# Access Compliance Report

## Public Rights-of-Way

Intersection ID: 28079	Main Street: DELMAHOY_DR	Cross Street: PROVIDENCE_COUNTRY_CLUB_DR	Location: SE
ADA ID: 3638CFF07EA2	Ramp Type: Perp	Initial Pass/Fail: Fail	Overall Compliance: No
Severity Score: 12.5			
Codes/Mitigation Info/Possible Solution		Field Measurements/Component Compliance

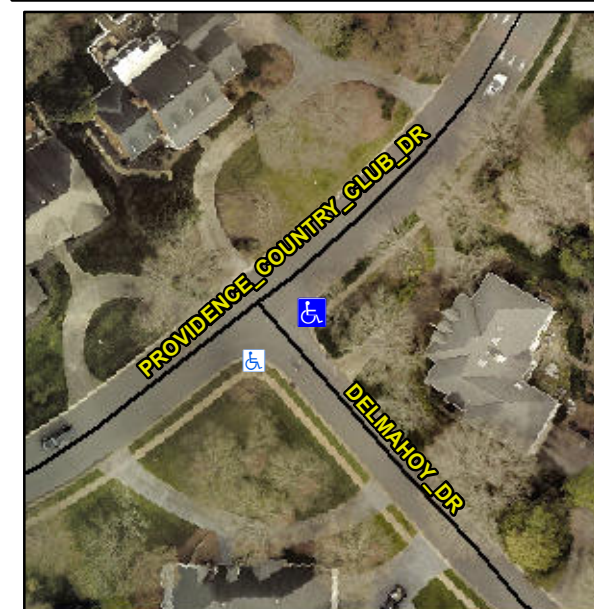
Compliance	Description	Data	Compliance	Description	Data
N/A	Ramp Length (in)	33.0	No	Ramp Slope (%)	9.8
Yes	Ramp Width (in)	48.0	Yes	Ramp XSlope (%)	0.5
N/A	Flare Type LT	N/A	N/A	Flare Type RT	N/A
N/A	Flare Slope LT (%)	N/A	N/A	Flare Slope RT (%)	N/A
N/A	Flare Traversable LT?	N/A	N/A	Flare Traversable RT?	N/A
N/A	Landing Length (in)	N/A	N/A	DWS Provided?	N/A
N/A	Landing Width (in)	N/A	N/A	DWS Contrast?	N/A
N/A	Landing Slope (%)	N/A	N/A	DWS Length (in)	N/A
N/A	Landing X Slope (%)	N/A	N/A	DWS Full Width?	N/A
N/A	Landing Curb? (Y/N)	N/A	N/A	DWS Offset (in)	N/A
N/A	Shared Landing?	N/A			
N/A	Gutter Ponding?	N/A	N/A	Gutter Slope (%)	N/A
N/A	Gutter Lip Ht (in)	N/A	N/A	Gutter X Slope (%)	N/A
N/A	Painted X Walk1?	No	N/A	Painted X Walk2?	N/A
	X Walk 1 Direction	To SW		X Walk 2 Direction	N/A
N/A	X Walk 1 Width (in)	N/A	N/A	X Walk 2 Width (in)	N/A
	X Walk 1 Slope (%)	2.0		X Walk 2 Slope (%)	N/A
	X Walk 1 X Slope (%)	0.5		X Walk 2 X Slope (%)	N/A

**Remove & Replace Entire Ramp.**
